Newton Corner Neighborhood Assn on Newton Corner Village Center Zoning

NCNA Meeting of December 1, 2022

Draft District Maps

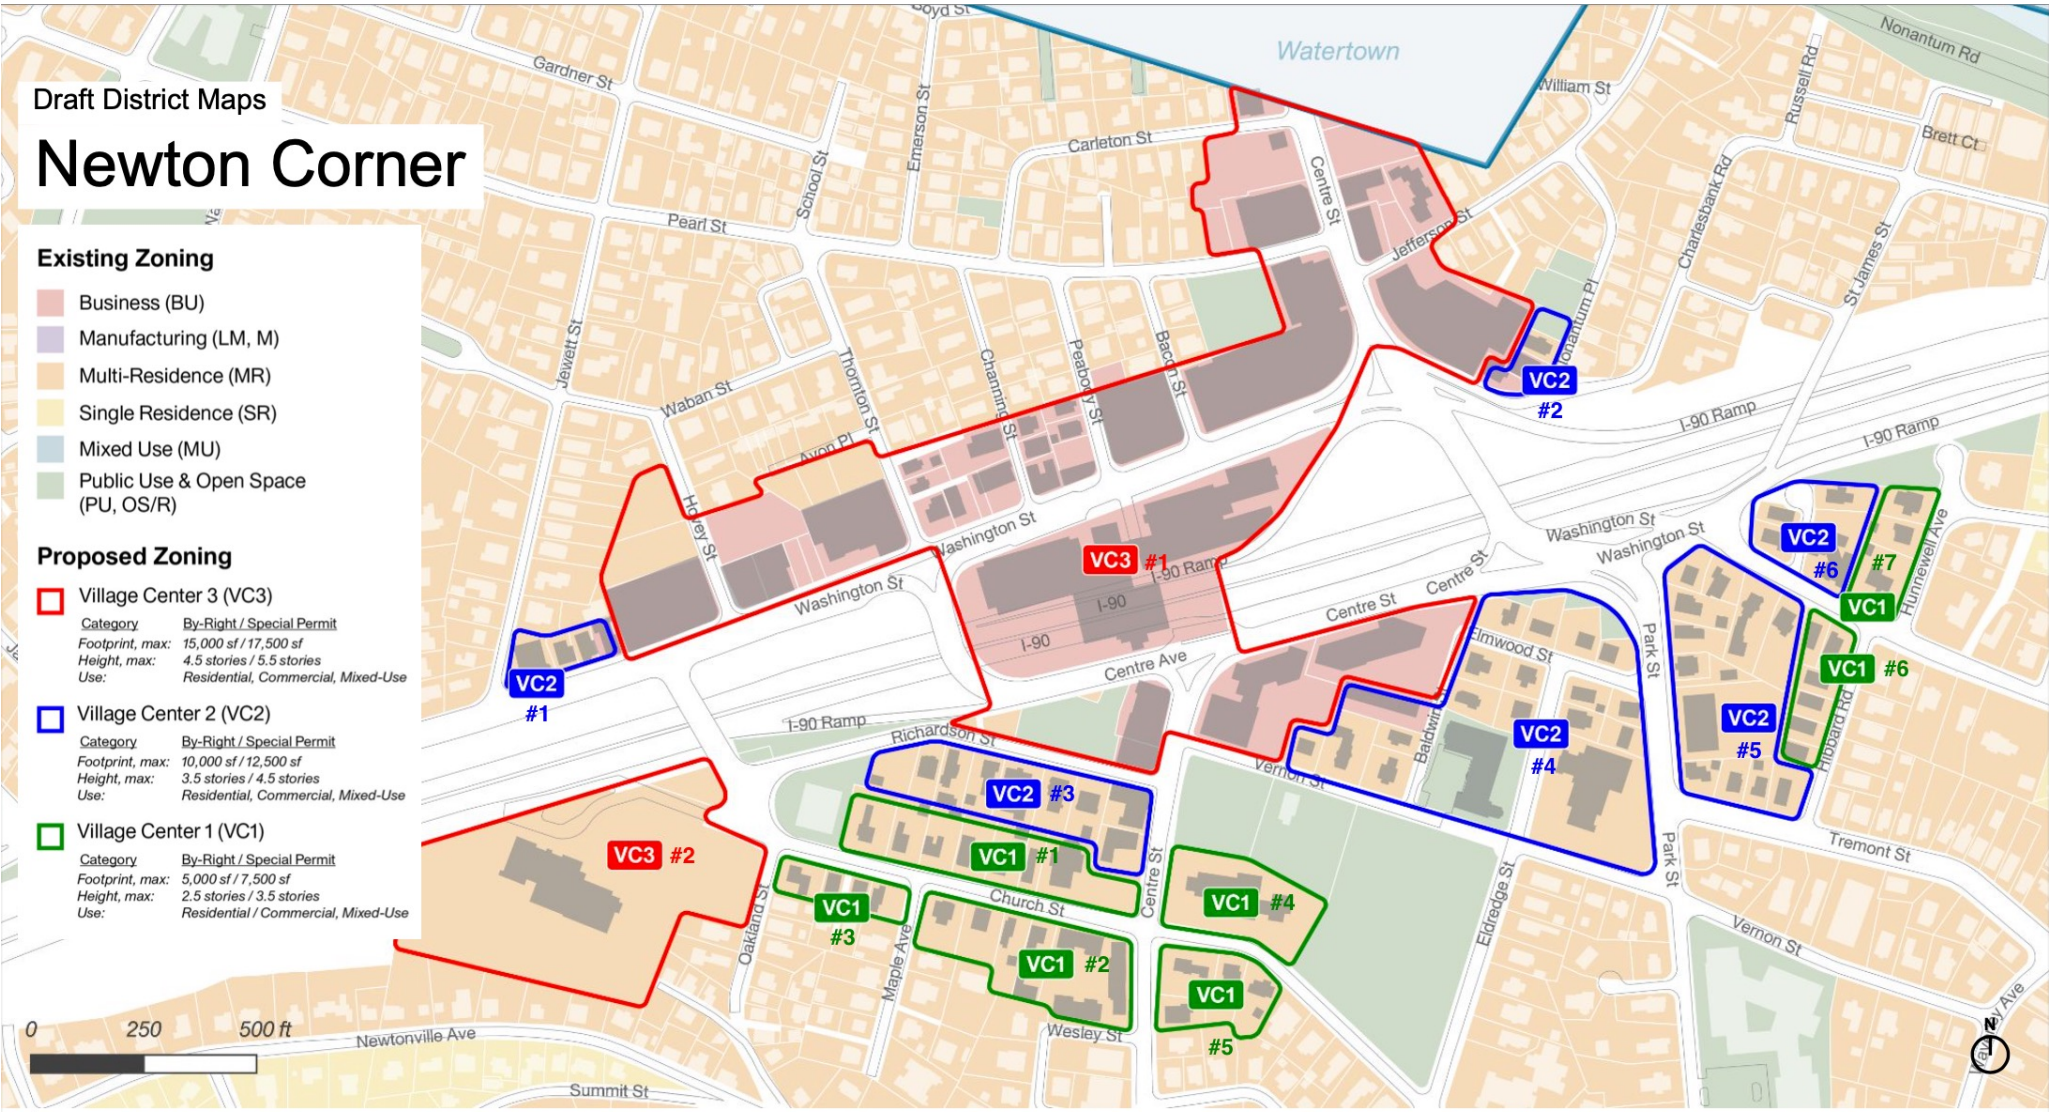
- Make VC1 residential only {city wide}
 - or replace VC1 by Rasala's proposed residential zone MRX
- Remove the 8 residential buildings from VC3 zone #1
 - 7 buildings north of Washington St
 - Peabody St: 21-23 Peabody St, 25-27 Peabody St
 - Channing St: 337 Washington St, 30-32 Channing St, 34 Channing St
 - Thornton St: 42 Thornton St, 44 Thornton St
 - 1 building east of Centre St
 - 65 Jefferson St
- Remove the Richardson St triangle from the VC3 zone and zone the triangle as VC2

- Delete VC2 zone #1 - Leave the 4 residential buildings as is
- In VC2 zone #2, remove the home (33-35 Nonantum Pl)
 - Leave only the 2 commercial buildings in this zone
- NCNA is OK with VC2 zone #3: Richardson St south

- VC2 zone #4 includes much too much area
- NCNA proposal for a more moderate zone:
 - The zone should be shrunk to include only the 4 residences whose backyards are along Washington St east and the 2 residences along Park St {west side}
 - Elmwood St: 9-11 Elmwood St, 15-17 Elmwood St, 23-25 Elmwood St, 29-31 Elmwood St
 - Park St: 41 Park St, 47 Park St
 - This zone would follow the curve from Washington St to Park St and would be a natural place for mixed use housing
 - This zone would contain approximately 75000 SF

- Under no circumstances should the Underwood elementary school be in a Village Center zone *of any level*
 - The Underwood school is currently an active school
 - Should Village Center zoning be successful, there will be a substantial increase in the Newton Corner population and the Underwood school will be an essential city asset
 - If at some time in the future the Underwood school is closed as a school, the community should have the first option to use the school as a community center along the model of the Hyde Community Center
- The remaining buildings in what is proposed as VC2 zone #4 in the current draft map should be rezoned as VC1

- VC2 zone #5 should be rezoned as VC1
 - NCNA is supporting multi use VC2 zoning directly across the street from this proposed VC2 zone. At that location, Park St is a very wide street with lots of traffic going in both directions given closeness to the Newton Corner traffic circle, the turnpike, and Tremont St. There does not seem to be a good case for also having a VC2 zone on the east side of Park St that stretches around the corners to both Washington St and Tremont St. Because of the flow of traffic and the width of Park St, there would be no natural connection between the west and east sides of Park St.
 - Once VC2 zone #5 is rezoned as VC1, it may be merged with VC1 zone #6 along Hibbard Rd to create one coherent VC1 zone using the entire block.

- NCNA currently supports the remaining VC1 zones provided that VC1 is defined as residential only {with no special permit exceptions}
- If it remains possible to build mixed use or commercial buildings in VC1 districts, NCNA withdraws its support of all VC1 districts
- NCNA feels it is the right of the neighborhood to retain as much of its current residential character as possible given the history of damage to the Newton Corner community from:
 - Building the turnpike through the middle of the village center
 - Having entrance and exit ramps that feed directly into the village center creating the circle of death
 - Having many massive buildings built (the hotel and several office buildings)

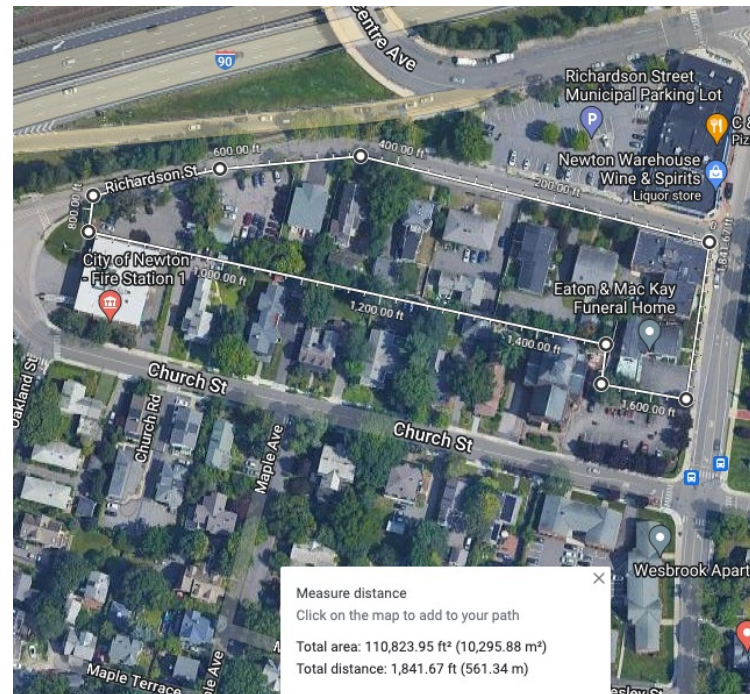
- Delete VC2 zone #6
 - This zone includes 1 apartment building and 3 homes around the cul-de-sac of St James Circle off Washington St south of the turnpike. This zone is mere feet from the east bound entrance ramp of the turnpike. The area has no extra parking and little foot traffic since there is no safe way to cross the entrance ramp to get to the north side of the turnpike. It is impossible to see how this zone is a viable place for business.
- Delete VC1 zone #7
 - This zone was placed on the map only because of the VC2 zone #6. Once VC2 zone #6 is deleted there is no rationale to keep VC1 zone #7
